Access Compliance Report

Public Rights-of-Way (Curb Ramps)

Intersection ID: 2776	Main Street: BEAUVISTA_DR	Cross Street: OAK_COVE_LN	Location: SE
ADA ID: FED9538D002C	Ramp Type: PerpDiag	Initial Pass/Fail: Fail	Overall Compliance: No
Severity Score: 46.25			
Codes/Mitigation Info/Possible Solution		Field Measurements/Component Compliance

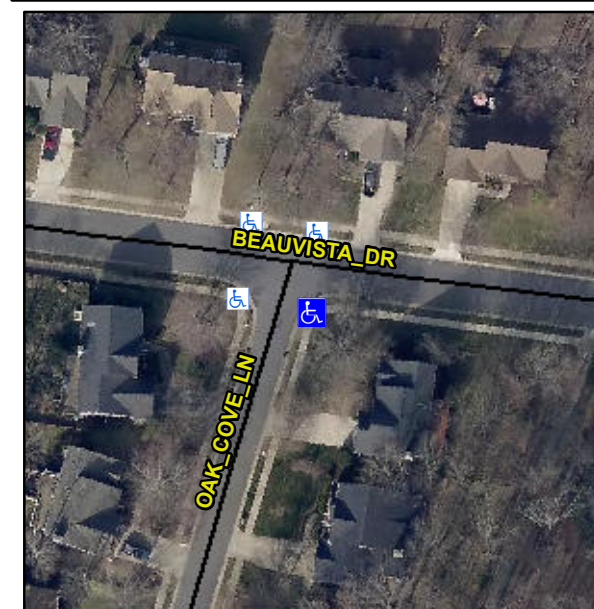
Not Found, R304.5.1, R304.2.2, R304.5.3

Compliance	Description	Data	Compliance	Description	Data
N/A	Ramp Length (in)	45.0	No	Ramp Slope (%)	12.6
No	Ramp Width (in)	43.0	No	Ramp XSlope (%)	5.1
N/A	Flare Type LT	N/A	N/A	Flare Type RT	N/A
N/A	Flare Slope LT (%)	N/A	N/A	Flare Slope RT (%)	N/A
N/A	Flare Traversable LT?	N/A	N/A	Flare Traversable RT?	N/A
N/A	Landing Length (in)	N/A	N/A	DWS Provided?	N/A
N/A	Landing Width (in)	N/A	N/A	DWS Contrast?	N/A
N/A	Landing Slope (%)	N/A	N/A	DWS Length (in)	N/A
N/A	Landing X Slope (%)	N/A	N/A	DWS Full Width?	N/A
N/A	Landing Curb? (Y/N)	N/A	N/A	DWS Offset (in)	N/A
N/A	Shared Landing?	N/A			
N/A	Gutter Ponding?	N/A	N/A	Gutter Slope (%)	N/A
N/A	Gutter Lip Ht (in)	N/A	N/A	Gutter X Slope (%)	N/A
N/A	Painted X Walk1?	No	N/A	Painted X Walk2?	No
	X Walk 1 Direction	To NE		X Walk 2 Direction	To W
N/A	X Walk 1 Width (in)	N/A	N/A	X Walk 2 Width (in)	N/A
	X Walk 1 Slope (%)	3.9		X Walk 2 Slope (%)	3.3
	X Walk 1 X Slope (%)	1.9		X Walk 2 X Slope (%)	1.5

N/A	Ramp inside XWalk1?	N/A	N/A	Ramp inside XWalk2?	N/A
	Road Slope (%)	3.7	N/A	Clear Space?	N/A
	Road X Slope (%)	4.5	N/A	Clear Space to XWalk (in)	N/A
N/A	Any Obstructions?	N/A	N/A	Storm Grate/Utility Hazard?	N/A
	Obstruction Type			Storm Grate/Utility Type	
		N/A			N/A
			Yes	Surface Condition? (G/P)	Good

Remove & Replace Curb Ramp With Two New Directional Ramps or Equivalent.
